Town of Lake Park, Florida

Special Call Historic Preservation Board Meeting

HPB 24-001: QUASI JUDICIAL HEARING TO CONSIDER A REQUEST FOR A SPECIAL CERTIFICATE OF APPROPRIATENESS TO ALLOW THE REPLACEMENT OF A ROOF FOR A LOCALLY HISTORICALLY DESIGNATED HOME LOCATED AT 250 FORESTERIA DRIVE

Agenda Item # HPB 24-001

Figure 1 - Diagonal Lumber Shear Wall Sheathing Diagram

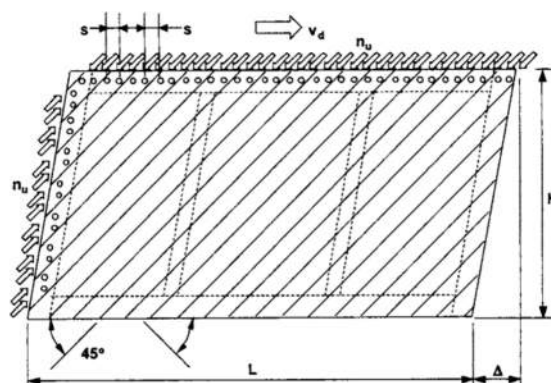
From the inside of the building, the exterior walls are noticed to be sheathed with diagonal or batten boards (see photos 005 and 028). Along the East/West direction of the building, the diagonal boards are seemed spaced at $\pm 16"$ OC (see photo 029) and not directly abutting each other as were noted along the North/South direction exterior walls. This framing condition does not provide continuous lateral resistance to the exterior shear walls, making them inadequate to sustain the lateral forces produced by a major hurricane. Figure 1 shows the proper assembly for diagonal lumber shear wall sheathing, to be able to resist in-plane lateral forces.

Photo No. 015
Date Taken: 07/10/2023
File Name: 20230710_174932538
Description: Underside of exterior wood-framed stairs

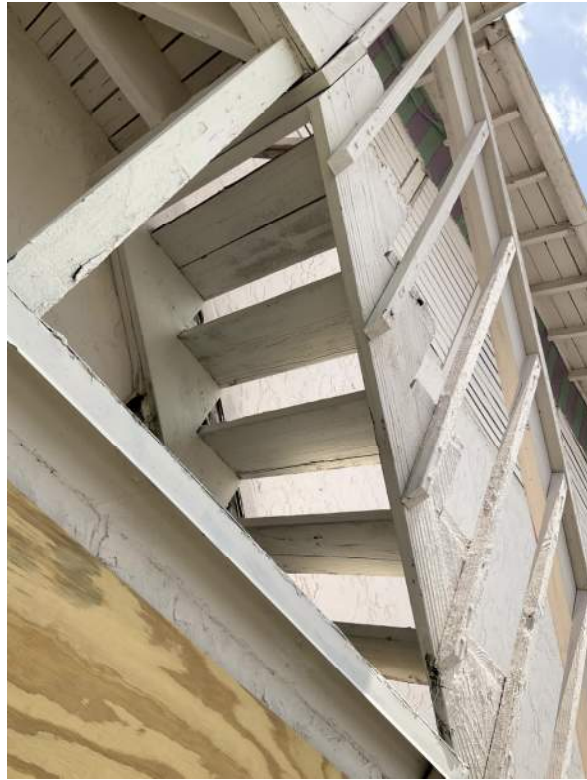
Comments: Toenailing of threads and stringers is not acceptable per the FBC. Railing does not meet FBC height and spacing requirements

Photo No. 025
Date Taken: 07/10/2023
File Name: 20230710_180559152
Description: Original building rear wall

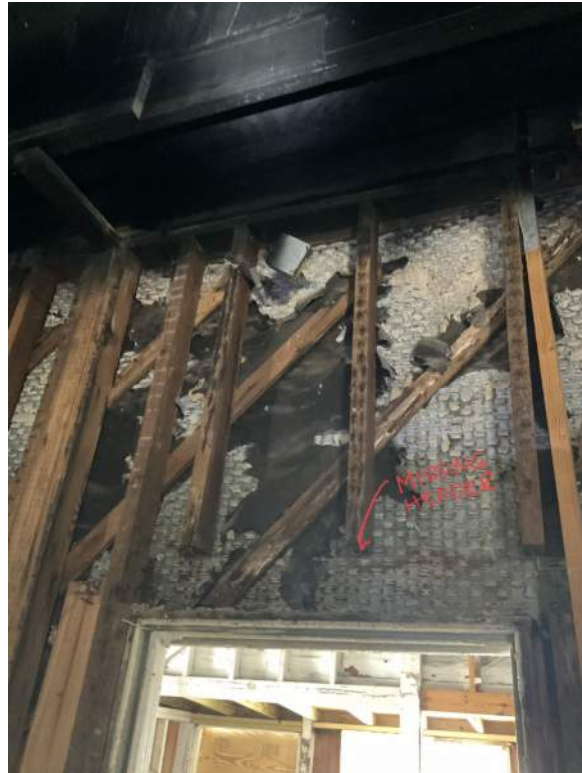
Comments: Missing door header,
exposed stucco lath,
spaced diagonal exterior
sheathing, missing interior
wall finish
